## PRODUCT CHANGE NOTIFICATION

#PCN-IFC-QICI-14

Business Unit	Product Line Code	Type of Change	Action	Date of issue
IFC	BF7	Aesthetic	Notify Distributors and Field	12/19/2014

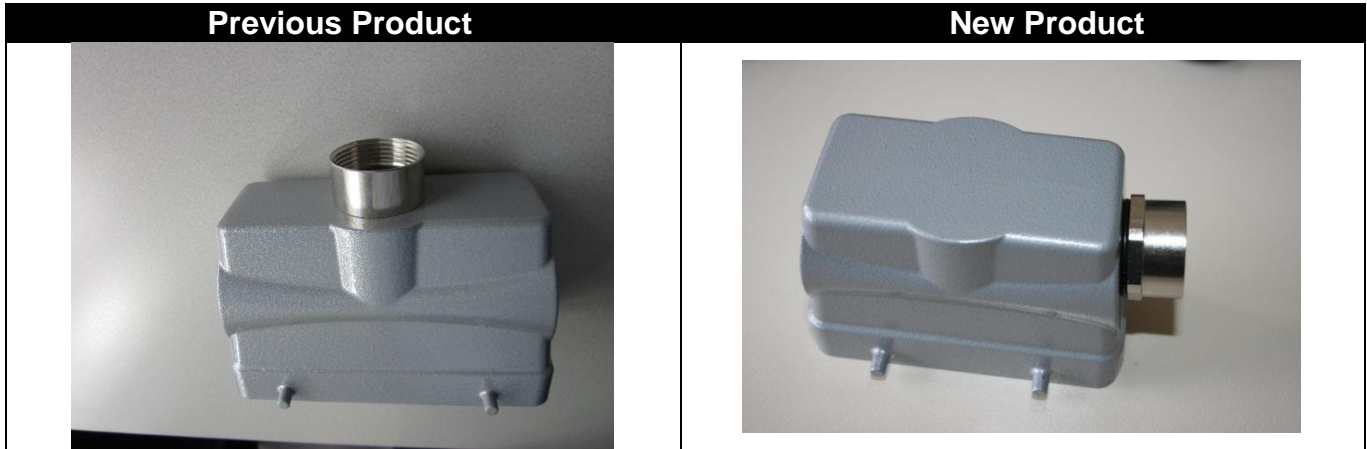
The cable gland exit on the HC-B, HC-D and HC-HV series housings has a minor change in which the threaded support collar, which was formerly bonded into place, will now be substituted by a screwed in hexagonal gland body with an O-ring.
